DRAFT REPORT

Dam Safety Assessment of CCW Impoundments

WH Zimmer Station

United States Environmental Protection Agency
Washington, DC

FIGURE 3

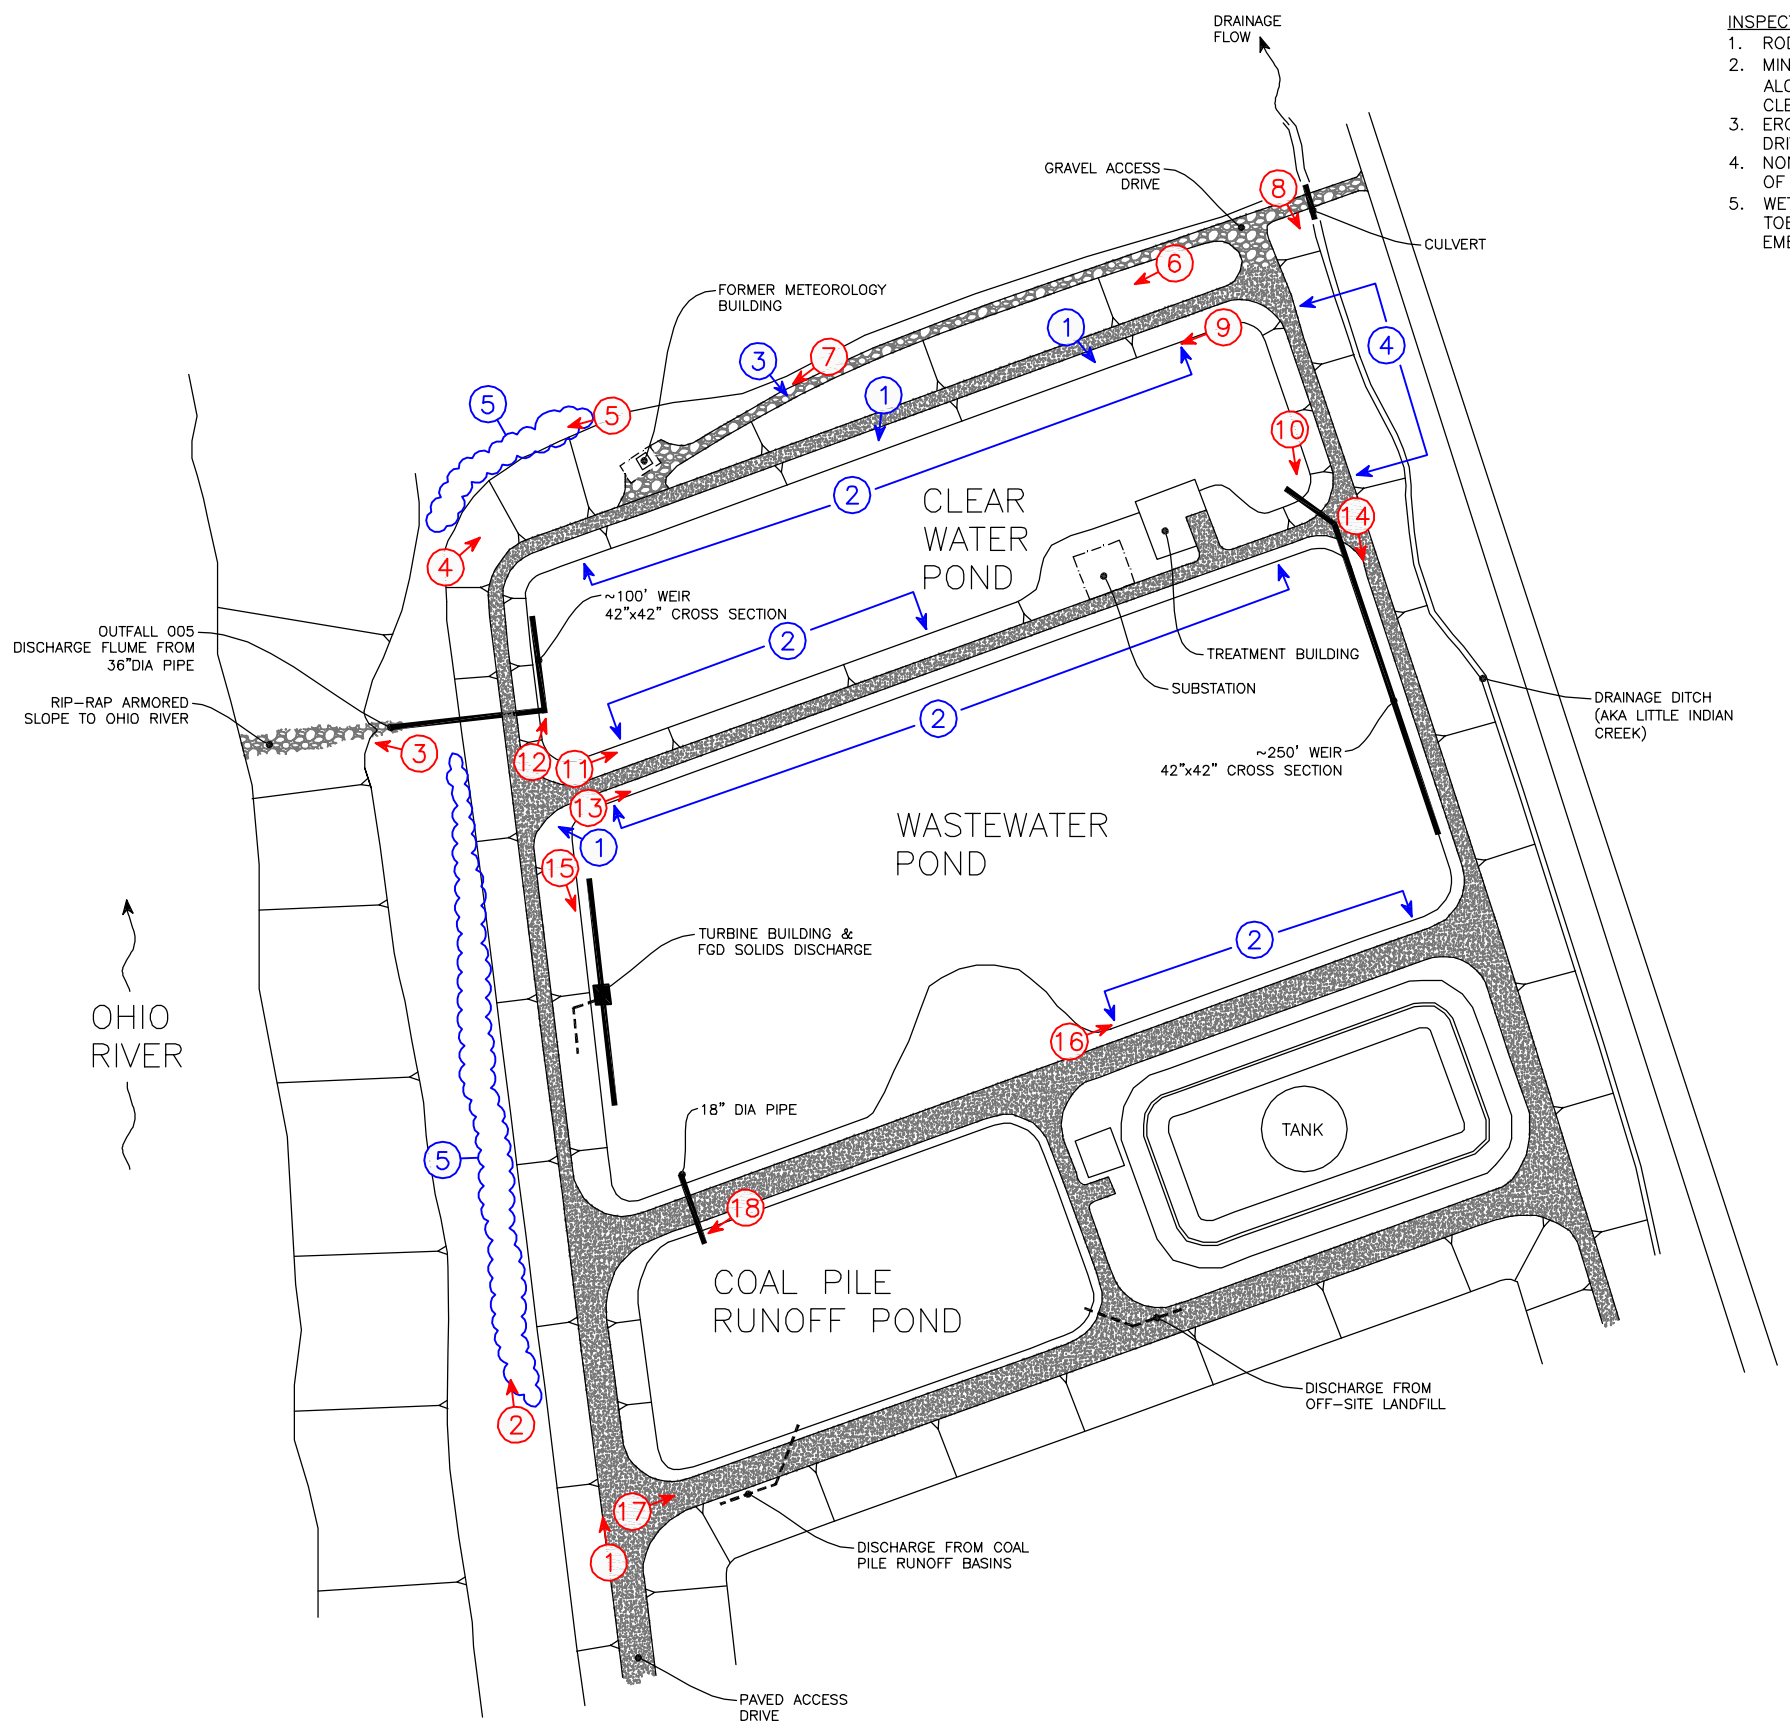
1. RODENT BURROW(S)
2. MINOR SCARPING/WAVE ERODED AREAS ALONG WATER'S EDGE OF WASTEWATER AND CLEAR WATER PONDS
3. ERODED GULLY ACROSS GRAVEL ACCESS DRIVE ON NORTH EMBANKMENT
4. NON-UNIFORM SLOPE AT NORTH PORTION OF EAST EMBANKMENT
5. WET/POORLY DRAINED AREAS OBSERVED AT TOE ALONG WEST EMBANKMENT AND NORTH EMBANKMENT

- Filling of noted rodent burrows and elimination/relocation of rodents

- Regrading to promote positive drainage of wet areas along the outboard toe of the west embankment and western portion of north embankment.

- Scarping/wave erosion in Wastewater and Clear Water Ponds
- Non-uniform slope at the north end of the east embankment
- Erosion on secondary access road on north embankment
